DEVELOPMENT APPLICATION

PLOT PLAN

601 OCEAN ROAD
BLOCK 20 - LOT 17
FOR AC CONSTRUCTION MGT. LLC.

**Re: Residential Bulk Variance Application
Block 20, Lot 17
601 Ocean Road
Spring Lake Heights, NJ
Our File SLHBA 19-10**

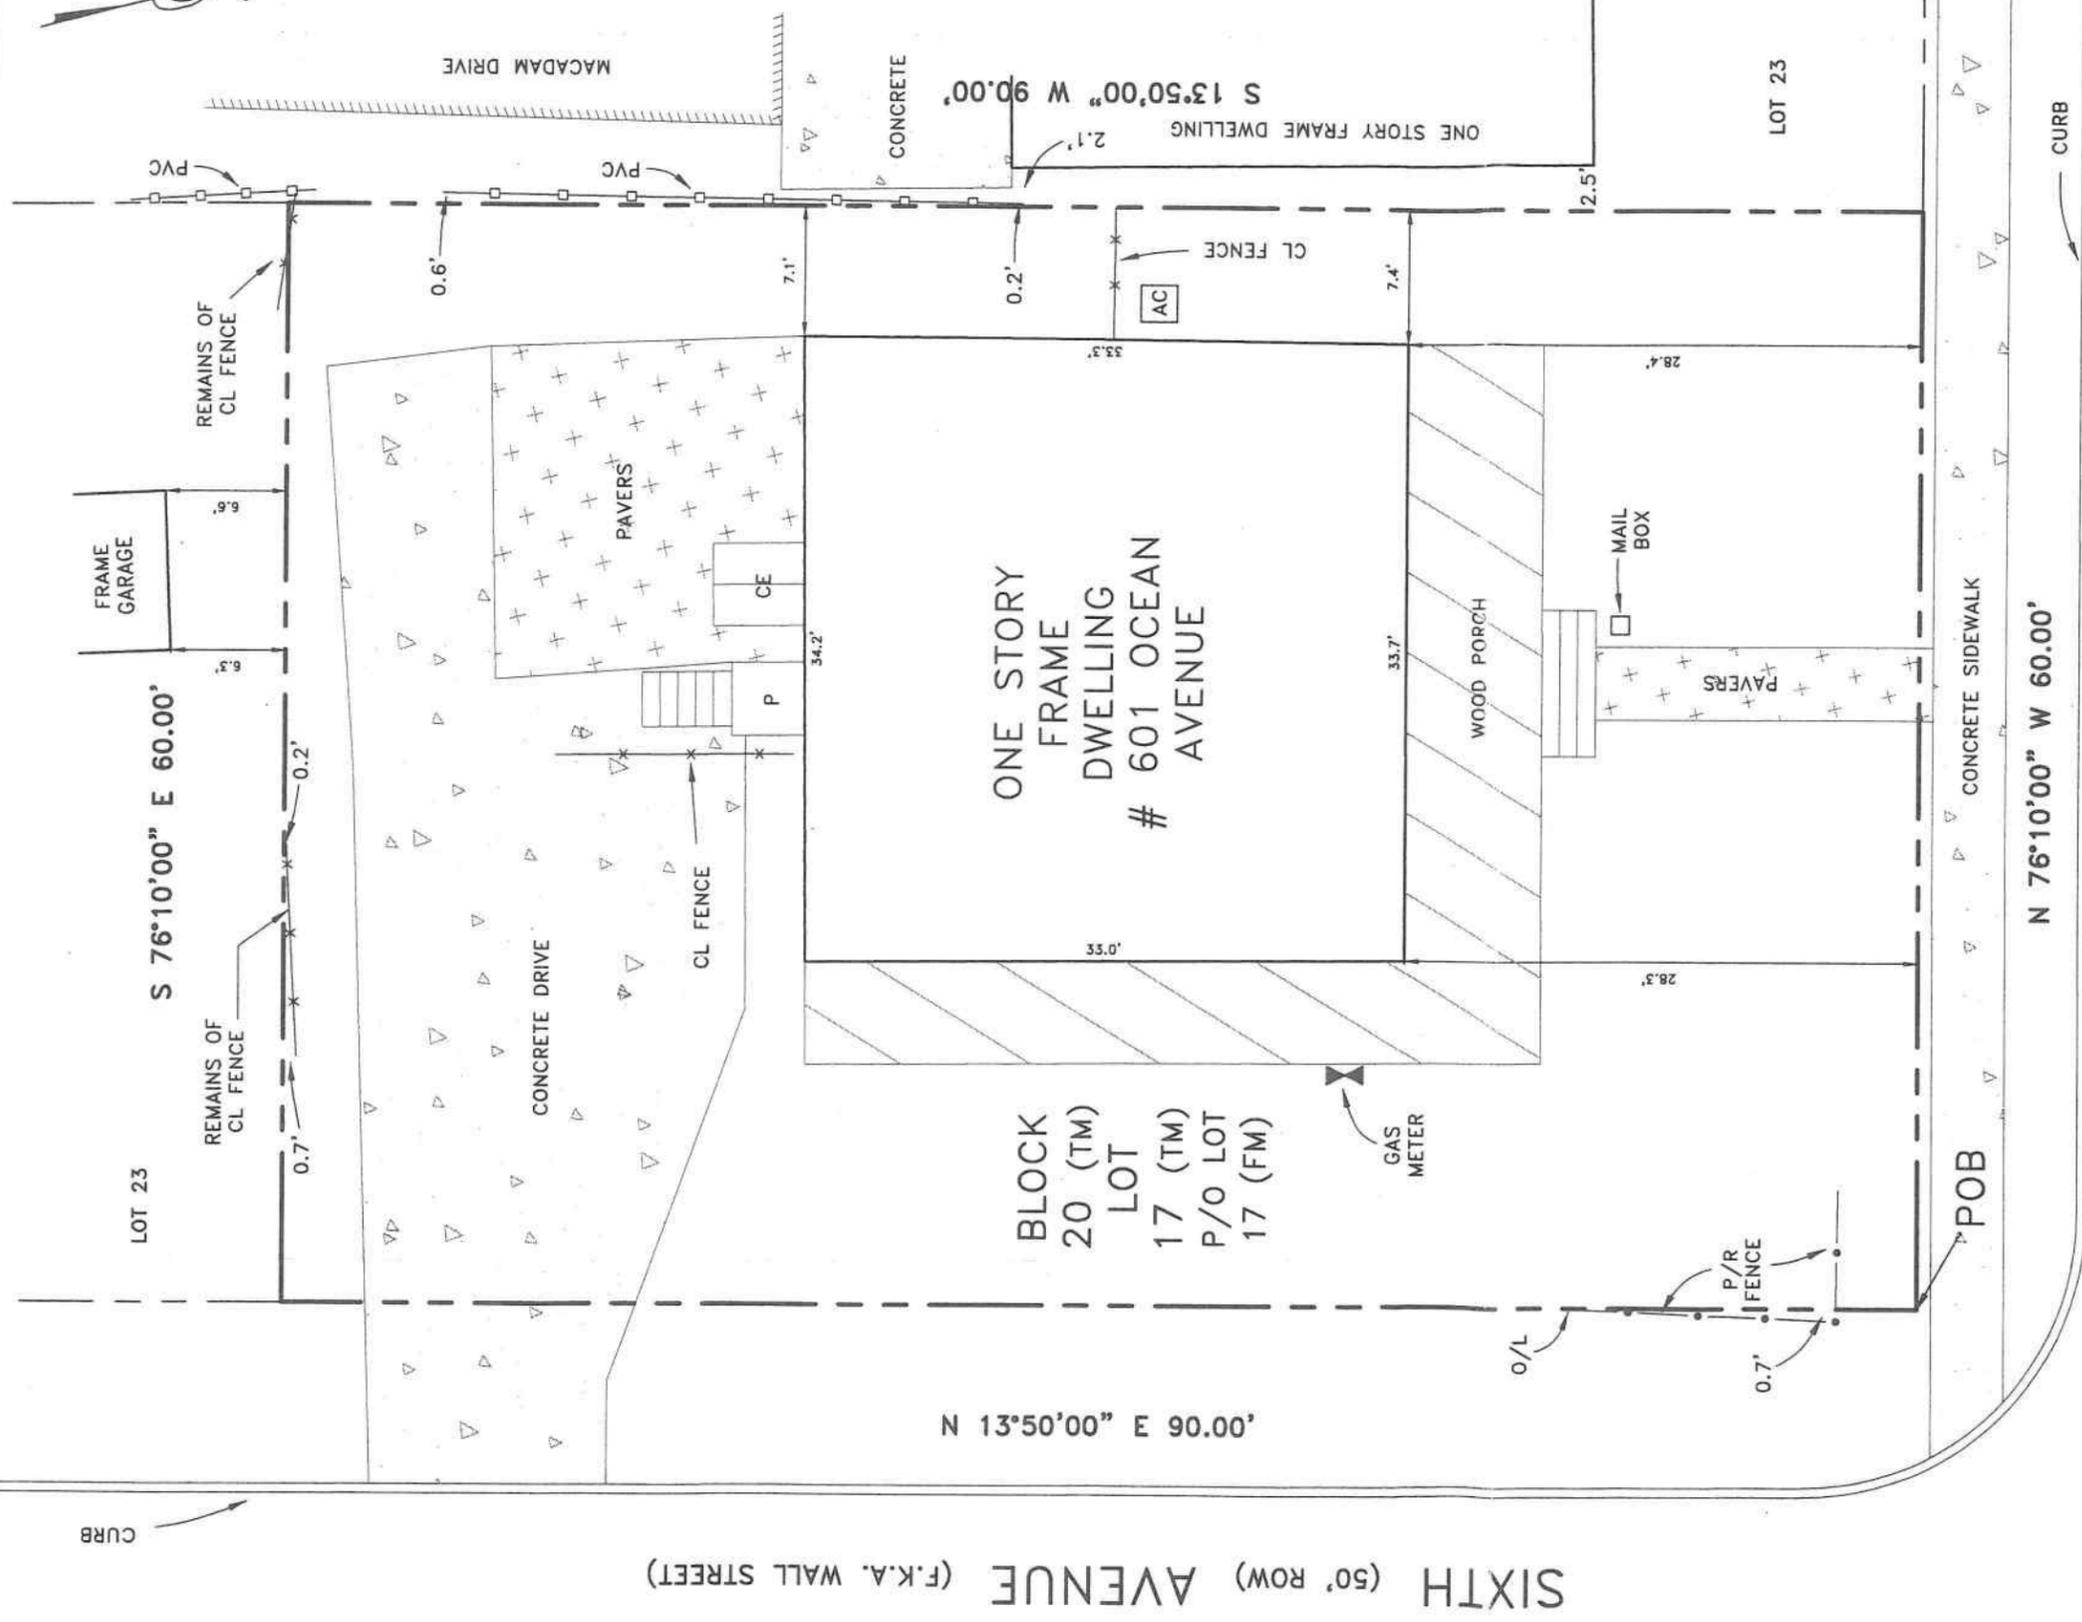
The Applicant's proposal appears to require the following variances:

1. A front yard setback off 6th Avenue of 23.84' where 30 feet is allowed although Ordinance 22-517.6 states a permit can allow reduced yard and height provisions 72% to 21.6'
2. No screening of the A.C. pad

1. The Applicant should provide an aerial photograph that clearly shows the property, the nearby area and the front setbacks of neighbors along Ocean Road and 6th Avenue.
